Subject: Additional information provided per your email dated Thursday, November 5, 2015 concerning the **CDC Radioactive Waste Room #1 Decommissioning Plan; NRC License No. 10-06772-01, Docket No. 03004001.**

CDC RAW Room #1 Decommissioning Plan

Prepared for:
**U.S. Department of Health & Human Services
Centers for Disease Control & Prevention
4770 Buford Highway
Chamblee, GA 30341
Radioactive Materials License #10-06772-01**

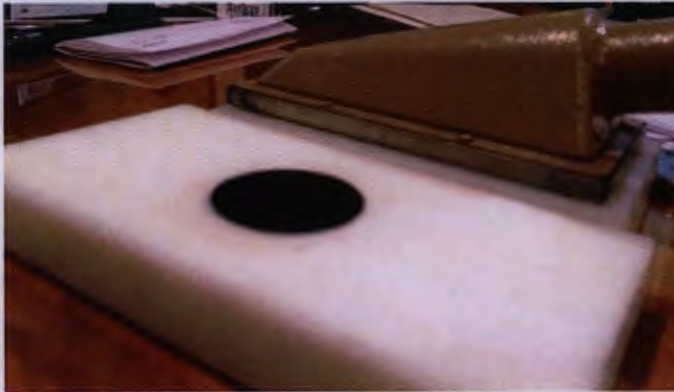
- A. Not enough specific information is given to verify estimated MDC and determine proper alpha scan rate. Please submit the variables and inputs associated with total efficiency with beta and alpha counts.

Please see revised plan, Section 8.3 – Determination of Counting Times and Minimum Detectable Concentrations updated to include all inputs, calculations and results based upon actual Scoping Survey inputs.

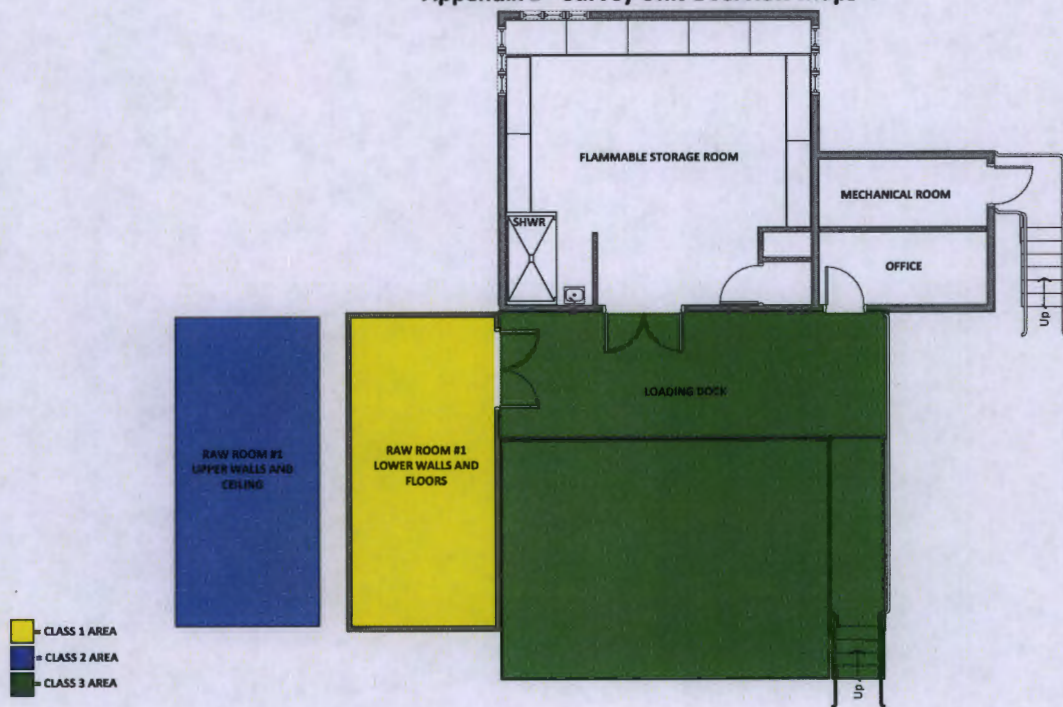
6. Section 17.2 Data Quality Objectives states that the MDC static of less than 50% of the DCGL. This is normally acceptable, however the three DCGL calculations need to be combined as stated in section 5.3.2.3. With the given unity calculation and the stated MDC, there is potential that 10 CFR 20 subpart E release criteria could be exceeded without the survey plan identifying the condition. Please adjust the Data Quality Objective to compensate for this condition.

Data Quality Objectives have been adjusted to compensate for the stated condition in Section 5.3.2.3 – Unity Calculations as follows in Section 17.2 – Data Quality Objective.

Centers for Disease Control and Prevention
RAW ROOM #1 - First Floor
Appendix B - Survey Unit Overview Maps

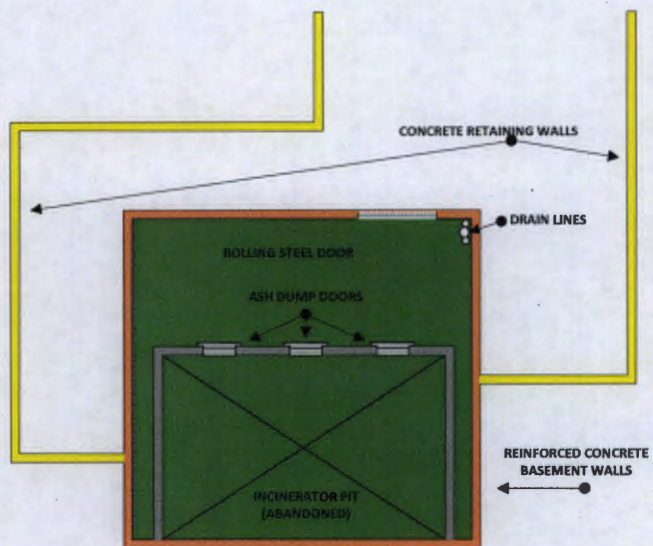
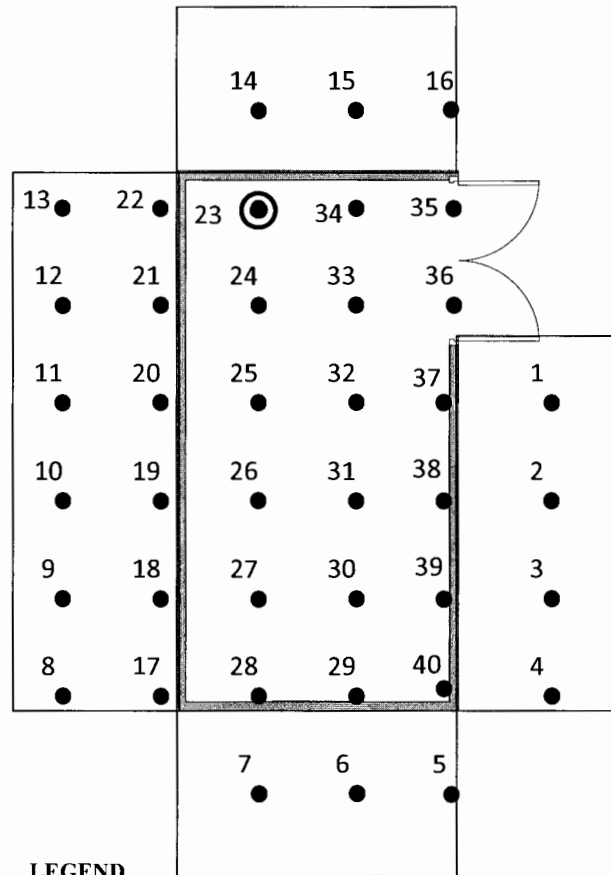
- Quality Assurance Surveys will be conducted at a rate of 5%.
7. Please provide a simple diagram of the different survey units and building structures for clarity of the area.

Appendix A and Appendix B provided with the initial Decommissioning Plan include the diagrams of the different survey units and building structures. In addition, Section 17.8.5.1 – Determining Class 1 and Class 2 Sample Locations now includes a survey location map containing the area, the random start location, total area of the survey unit, and sample spacing as a reference. Examples for Appendix B and the survey location map provided below.
